Amendment Notice: Passenger Pick-Up and Drop-Off (PUDO) Standard

This bulletin applies to and amends the following document:

- GO Design Requirements Manual (DRM), GO-DRM-STD-2017 Revision 3, dated February 2020

- Revisions to GO DRM Feb. 2020 - Passenger Pick-Up and Drop-Off (PUDO) Standard

Figure 13-1: Peak Ridership/Ferry Style Configuration

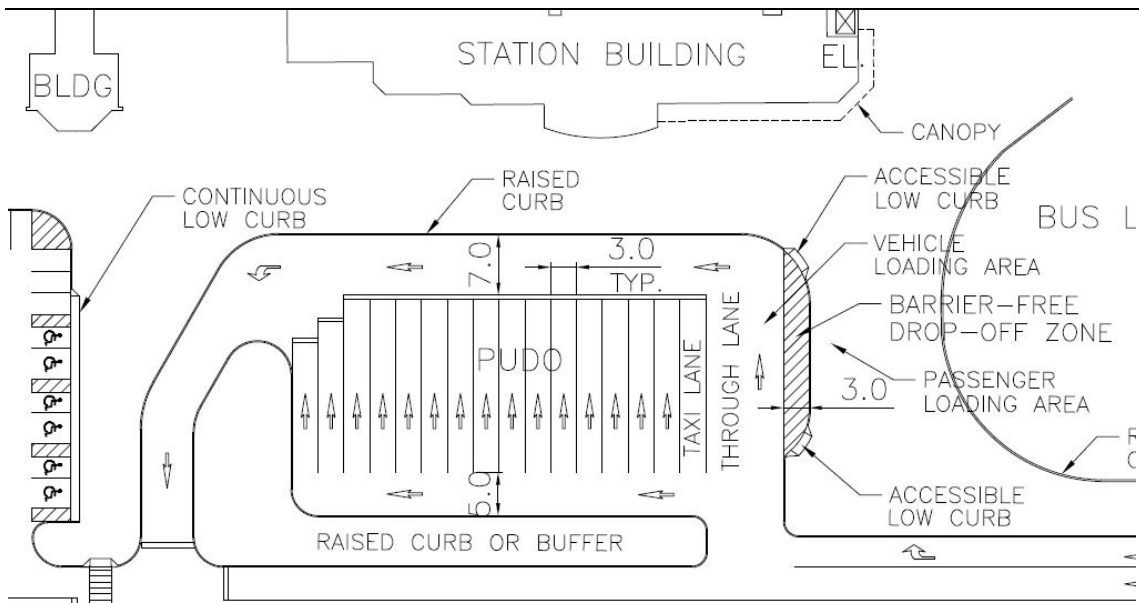
- ~~Be a~~ **Shall be** lineal, parallel layout, sized on the basis of passenger loading and vehicle projections, allowing a space 3000 mm wide by 6000 mm long for each vehicle. Where possible, provide more lanes of shorter length to allow for easier vehicles access and exit.

- Include a 3000 mm wide hatched area for rear lift equipped vehicles as well as side mounted lifts.
- Ensure a barrier-free drop-off zone complete with curb cuts and dedicated vehicle and passenger loading /unloading area to be located on the right to discharge passengers at the curb or walkway and shall not intersect with the bikeways, MUP or the accessible path of travel.

- **Physical separation shall be achieved** ~~Allow physical separation~~ through a minimum 2500 mm wide, raised curb or landscaped buffer **between PUDO facility and general vehicle traffic flow.**

- Taxi Lane shall be part of the PUDO **which shall accommodate taxis, ride-sourcing, and micro-transit vehicles.**

Figure 13-2 High Ridership Configuration

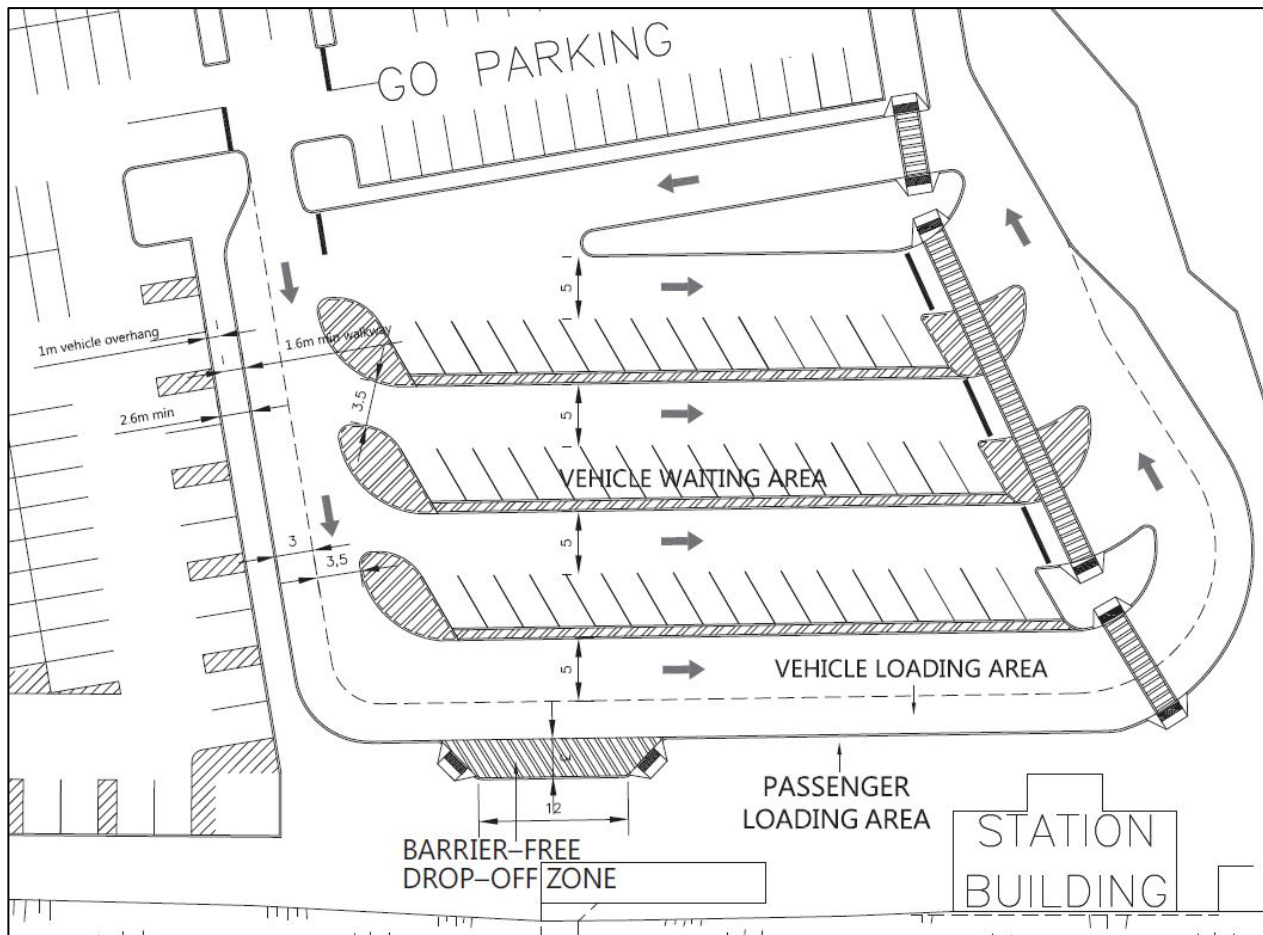
The High Ridership Configuration has modular Vehicle Waiting Areas and channelized lanes for vehicles to safely maneuver in and out of the PUDO. The pedestrian walkway shall contain both raised pedestrian islands and painted/tactile markings to allow for easier access of maintenance vehicles through the PUDO.

- Where pedestrian crossings of perpendicular traffic flows are required, a channelized pedestrian walkway shall be provided with predictable and direct crossing locations that begin at the Passenger Waiting Area. Channelized crossing locations shall be well-marked and highly visible to drivers.

- The channelized pedestrian walkway shall include two raised islands with curb cuts.
- Additional traffic calming measures to reduce vehicle speed should be provided if required.

- The PUDO shall provide space to accommodate taxis, ride-sourcing, and micro-transit vehicles.
- Each space in the Vehicle Waiting Area shall be 6000 mm in length with an additional 1000 mm continuous hatched area across the front of each space

Figure 13-3 Strip Configuration

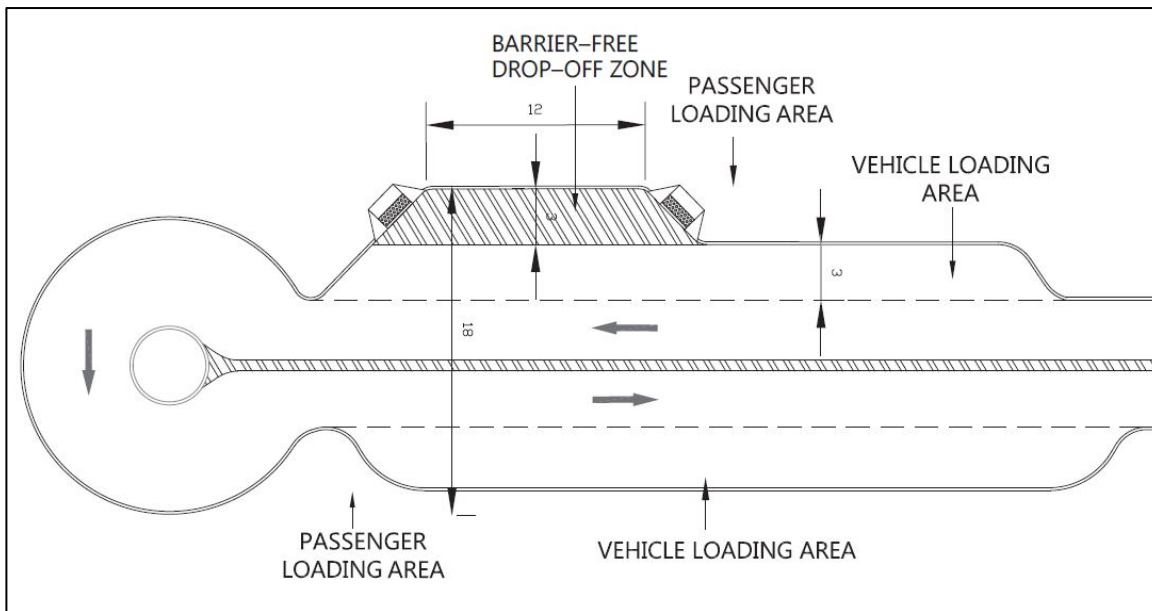
The Strip Configuration is designed to allow for a PUDO Facility on constrained station sites where the only available land may be within the 30 m set back from the rail corridor. It shall contain a raised but mountable island to allow for emergency vehicle access.

- The radius of the turnaround shall be the minimum required to accommodate service vehicles and allow for safe emergency vehicle access.

- Where pedestrian crossings of perpendicular traffic flows are required, pedestrian movements shall be channelized to a pedestrian walkway to predictable crossing locations. Channelized crossing locations shall be well-marked and highly visible to drivers.
- Should channelized crossings not be feasible given the configuration of this design and the required mountable island, traffic calming measures shall be used to limit vehicle speed.

Figure 13-4 Urban Configuration

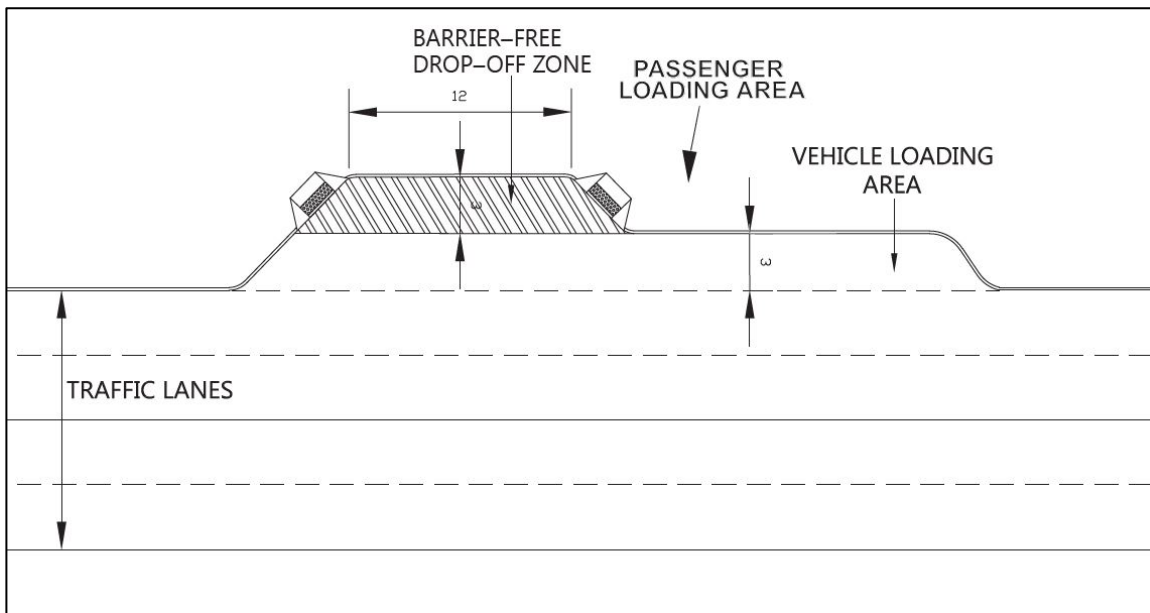
The Urban Configuration is designed for station sites where there are minimal, or no station lands available. This configuration requires coordination with the local municipality and/or agency at stations if this PUDO Facility will be located on a local road.

- No Vehicle Waiting Area shall be provided.

- The PUDO Facility shall be arranged to facilitate one-way traffic flow and discourage vehicle reversing movements and U-turns if located on a local road.
- The PUDO Facility shall avoid conflict with other road users.

- Where appropriate the PUDO Facility should contrast visually or tactilely from the adjacent local road to designate the Vehicle Loading Area.
